Access Compliance Report

Public Rights-of-Way

Intersection ID: 47698	Main Street: WATER_OAK_RD	Cross Street: LEES_COURT_ST	Location: SW
ADA ID: B125979396FB	Ramp Type: PerpDiag	Initial Pass/Fail: Pass	Overall Compliance: No
Codes/Mitigation Info/Possible Solution		Field Measurements/Component Compliance	
Severity Score: 10

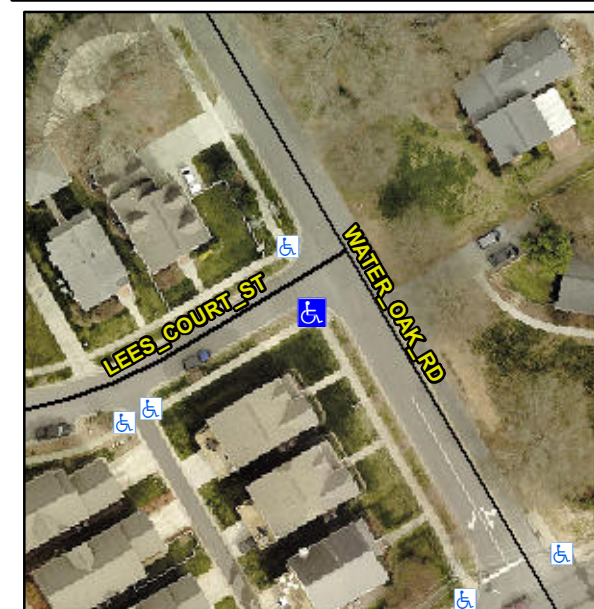
R304.2.1, R304.2.2-Perp, R304.3.2-Para, R304.5.3, R305.2

Remove & Replace Curb Ramp With Two New Directional Ramps or Equivalent.
